Forest Service Ecologist Recommendations

To:	Approval Section, Wexford <u>OR</u> Felling Section, Wexford	Approval Section
From:	Forest Service Ecologist	Katharine Duff
File/ Ref Number:	CN79324	
Townland	Sonnagh	
County	Mayo	
Applicant		
Date	13.12.2017

CN79324 Recommendations for the APPLICANT and REGISTERED FORESTER

Figure 1. CN79324 showing the site boundary, stream, River Moy SAC location, water set back and area for ABE

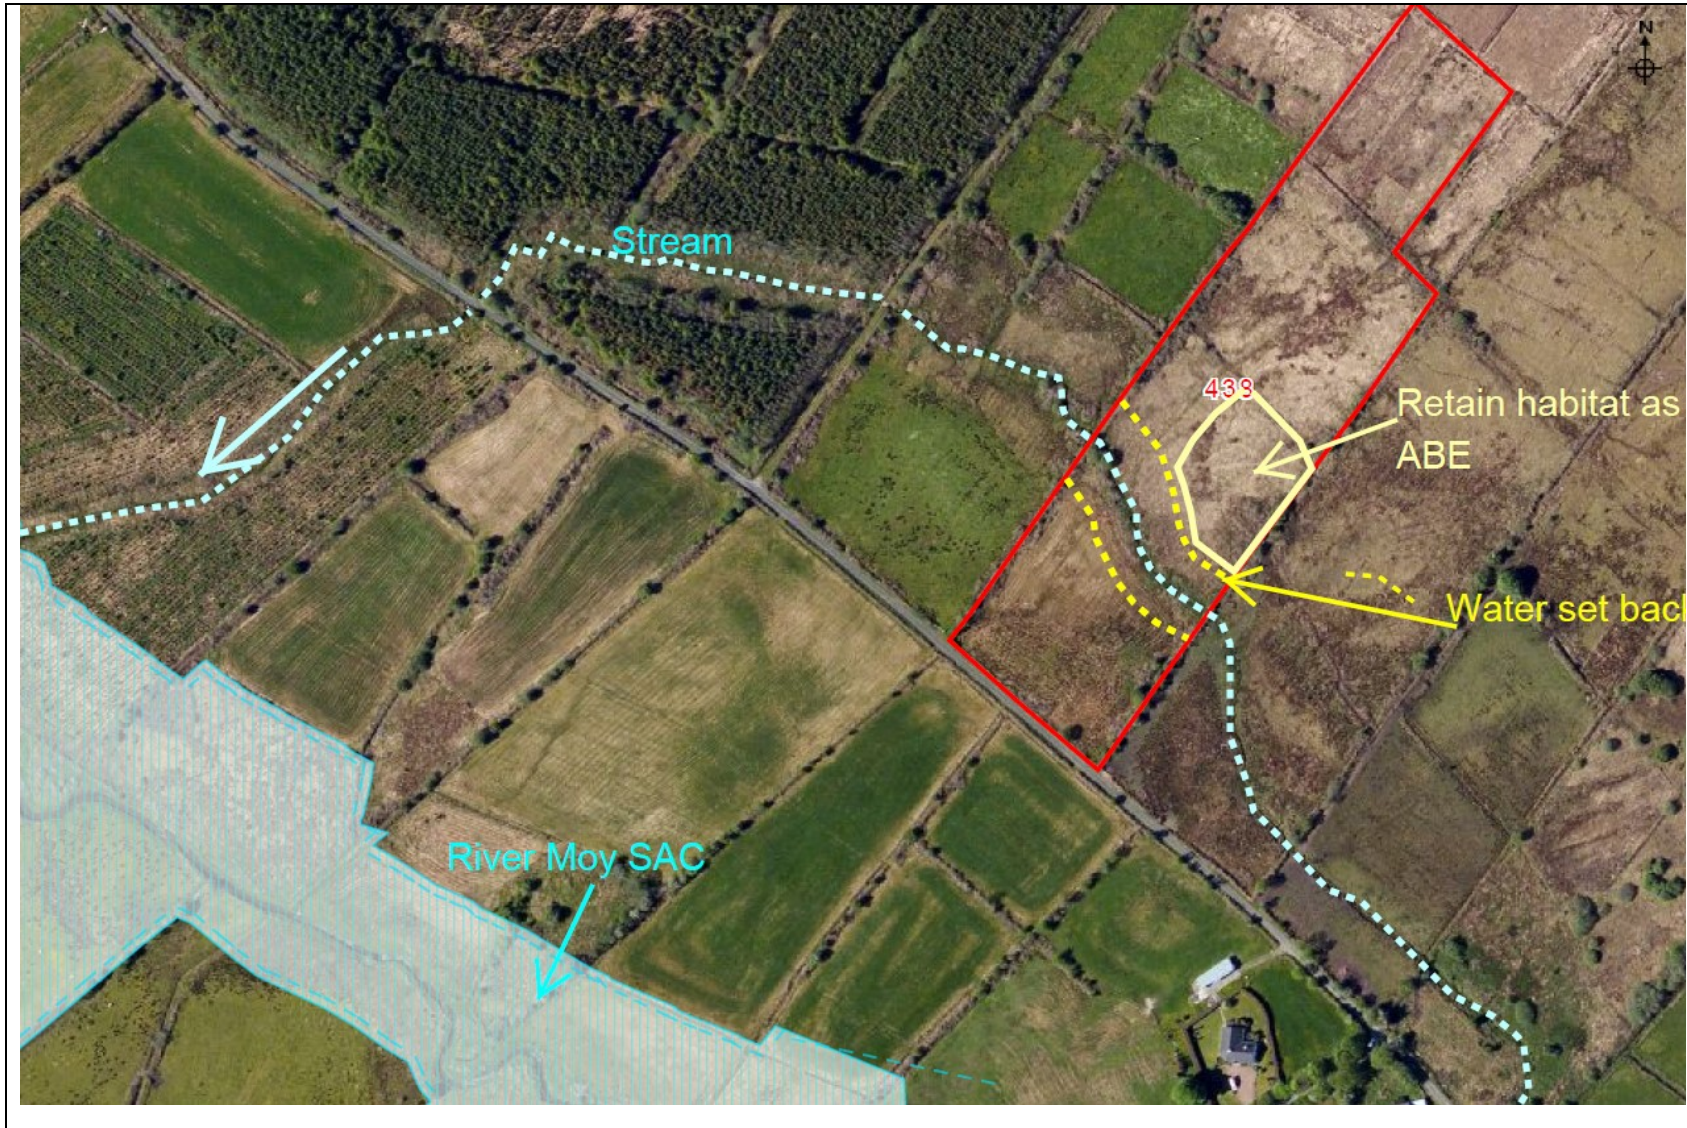
1. Apply a water set back of 20m. See Figure 1.
2. Adjacent to the water setback pit plant 5 rows of native broadleaves, except where the water set back adjoins the ABE, no additional broadleaf planting is required.
3. Retain the area of Marsh Fritillary habitat as an Area for Biodiversity enhancement (ABE). See Figure 1.
